Access Compliance Report

Public Rights-of-Way

(Curb Ramps)

Intersection ID: 3852	Main Street: DERBY_MEADOWS_CT	Cross Street: WOODCOCK_LN	Location: SE
ADA ID: F6CA15A940DA	Ramp Type: Perp	Initial Pass/Fail: Fail	Overall Compliance: No
Severity Score: 22.5			
Codes/Mitigation Info/Possible Solution		Field Measurements/Component Compliance

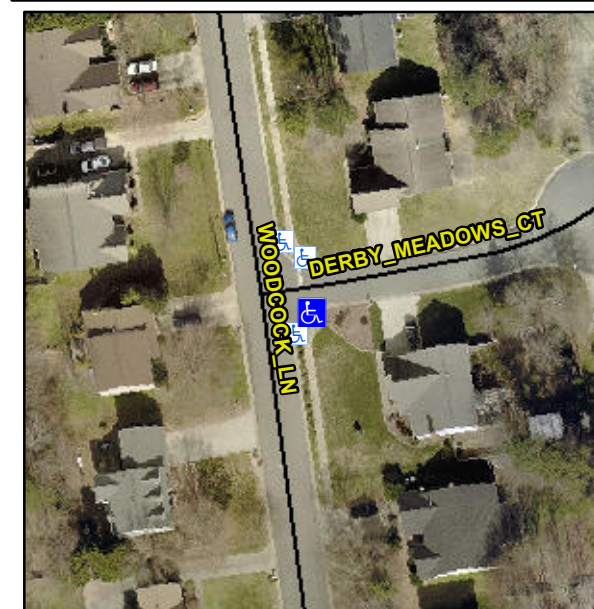
R304.5.1, R304.2.2, R304.5.3

Compliance	Description	Data	Compliance	Description	Data
N/A	Ramp Length (in)	51.0	No	Ramp Slope (%)	8.7
No	Ramp Width (in)	41.0	No	Ramp XSlope (%)	3.0
N/A	Flare Type LT	N/A	N/A	Flare Type RT	N/A
N/A	Flare Slope LT (%)	N/A	N/A	Flare Slope RT (%)	N/A
N/A	Flare Traversable LT?	N/A	N/A	Flare Traversable RT?	N/A
N/A	Landing Length (in)	N/A	N/A	DWS Provided?	N/A
N/A	Landing Width (in)	N/A	N/A	DWS Contrast?	N/A
N/A	Landing Slope (%)	N/A	N/A	DWS Length (in)	N/A
N/A	Landing X Slope (%)	N/A	N/A	DWS Full Width?	N/A
N/A	Landing Curb? (Y/N)	N/A	N/A	DWS Offset (in)	N/A
N/A	Shared Landing?	N/A			
N/A	Gutter Ponding?	N/A	N/A	Gutter Slope (%)	N/A
N/A	Gutter Lip Ht (in)	0.5	N/A	Gutter X Slope (%)	N/A
N/A	Painted X Walk1?	No	N/A	Painted X Walk2?	N/A
	X Walk 1 Direction	To N		X Walk 2 Direction	N/A
N/A	X Walk 1 Width (in)	N/A	N/A	X Walk 2 Width (in)	N/A
	X Walk 1 Slope (%)	4.5		X Walk 2 Slope (%)	N/A
	X Walk 1 X Slope (%)	3.7		X Walk 2 X Slope (%)	N/A

Remove & Replace Entire Ramp.
